SERVICE BULLETIN T-07

Deactivation of xenon-type strobe lights

Applies to Taurus aircraft which were delivered before March 2011 and are equipped with NAV/Strobe wingtip lights.

Image 1: Aged, faulty xenon-type strobe light, which caused sparking

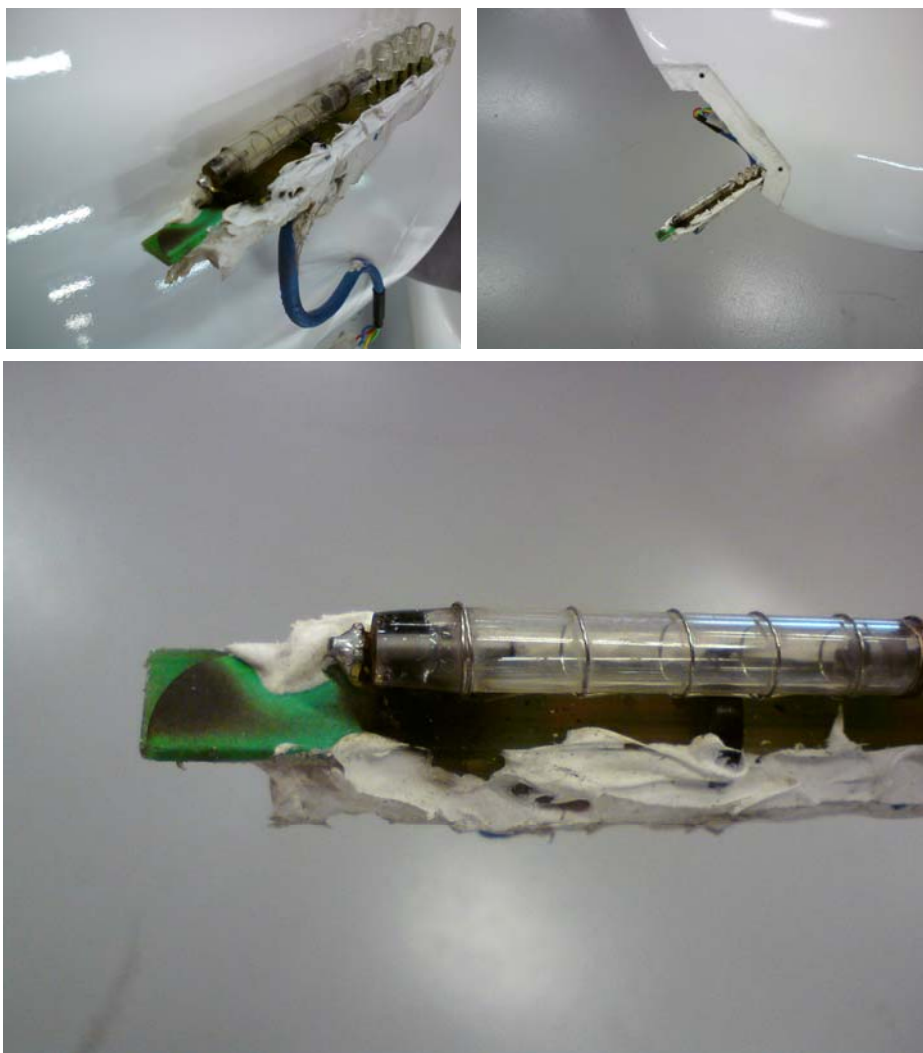
An incident occurred where the sparking from the strobe light ignited fuel fumes in/around the wing just after refueling and caused structural damage to the wing on a Sinus ultralight motorglider upon switching the lights on. The aircraft was still on the ground. The cause of the sparking was determined to be a faulty, aged, xenon-type strobe light. Upon investigation, it was discovered that large, 4 cm long sparks (1.75 inch) sparks were produced by the light unit in question.

In order to prevent eventual occurrences of sparking with other, similar type xenon-type strobe lights, used in airplanes with serial numbers listed on the cover page, it is required to disable the functioning of the strobe lights. NAV (red, green) lights in the same package are not problematic, as they are made with LED-technology.

Disable and/or remove the switch on the instrument panel, which controls the strobe lights.

Behind the cockpit, locate and remove the central unit of the NAV/Strobe lights. Use the Green and Blue wires from the wing cables to connect the NAV (LED technology) lights directly to the 12 V switch on the instrument panel. This option retains the functionality of the NAV lights and only disables the xenon-type strobes. Required work – 30 minutes, required material – AWG 18 wire approx 2 meters (6 ft), soldering gun or appropriate connectors.

Plug&play replacement packages are ready for shipping at a nominal cost for aircraft out of warranty. For aircraft still under warranty period, the replacements packages will be provided free of charge. Instructions on installation are provided as part of the replacement package. The new lights are all-LED based, therefore no sparking can occur.
